Vogtle Electric Generating Plant - Unit 1 (VEGP-1)
Inservice Inspection (ISI) Program
First 10-Year Interval
(ISI-P-006)

Revision 4 Summary of Changes

VEGP-1

RR-32

RESIDUAL HEAT REMOVAL HEAT EXCHANGER
NOZZLE TO VESSEL WELDS
(NOT TO SCALE)

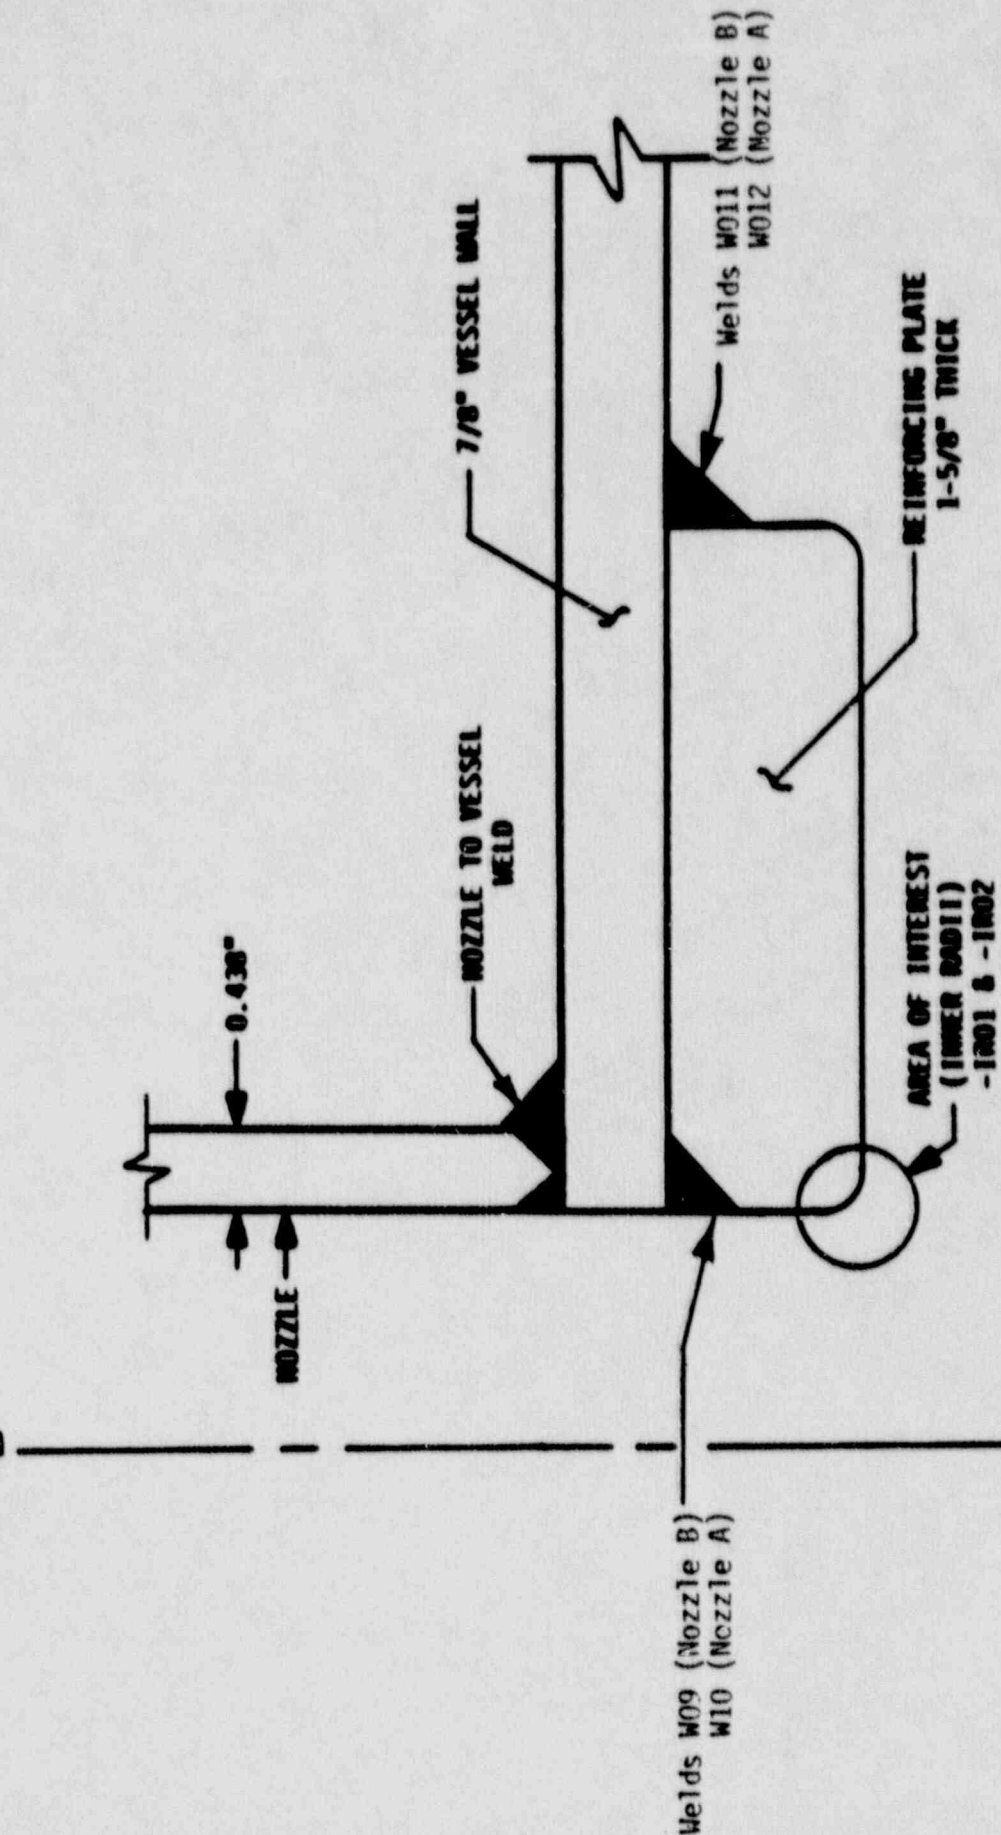
Relief Request RR-32 has been revised to include the surface examination of the reinforcing plate-to-vessel welds in the Residual Heat Removal System heat exchangers and to elaborate upon the relief requested. In addition, the figure accompanying the relief request has been revised to better depict the configuration at VEGP-1. The revised relief request is similar in content to RR-32 for VEGP-2.

- (1) Figure No. IWC-2500-4(c) of ASME Section XI which constitutes the examination requirement for Examination Area Identification Numbers IR01 and IR02 does not illustrate the nozzle design of the VEGP-1 RHR Heat Exchangers. The configuration of the nozzles at VEGP-1 differs from the configuration depicted in the Code figure. Attachment 1 depicts the configuration at VEGP-1. Although the reinforcing plate welded to the vessel has a rounded configuration in the flow path, it is not a true "nozzle inner radius" when compared with the configuration in Figure No. IWC-2500-4(c). It is not practical to perform an inner radius ultrasonic examination since the interface between the reinforcing plate and the RHR Heat Exchanger vessel wall precludes an adequate volumetric examination.

- (2) Figure No. IWC-2500-4(c) of ASME Section XI which constitutes the examination requirement for Examination Area Identification Numbers W09, W10, W011, and W012 does not illustrate the reinforcing plate-to-vessel design of the VEGP-1 RHR Heat Exchangers. Refer to Attachment 1 for the VEGP-1 configuration. The reinforcing plate at VEGP-1 is welded to the inside diameter of the heat exchanger wall with no nozzle-to-reinforcing plate contact (welds). The reinforcing plate-to-vessel welds are inaccessible. Therefore, it is impractical to perform a surface examination on the reinforcing plate-to-vessel welds W09, W10, W011, and W012 due to their inaccessibility.

- (1) As discussed above, due to the lack of true nozzle inner radii, an adequate ultrasonic examination cannot be performed for Examination Area Identification Numbers IR01 and IR02 for the VEGP-1 RHR Heat Exchangers due to the interface between the reinforcing plate and the RHR heat exchanger vessel wall. Those examination areas are to be deleted from the inservice inspection plan document since true nozzle inner radii do not exist.

- (2) Due to their inaccessibility, no surface examination of the reinforcing plate-to-vessel welds W09, W10, W011, and W012 can be performed. No alternate examination, e.g., volumetric examination, can be performed or is proposed due to the configuration involved. The interface between the reinforcing plate and the RHR heat exchanger vessel wall precludes an adequate volumetric examination from being performed for the aforementioned welds. No compensating increase in the level of quality and safety would be realized should an alternate examination, e.g., volumetric examination, be performed.
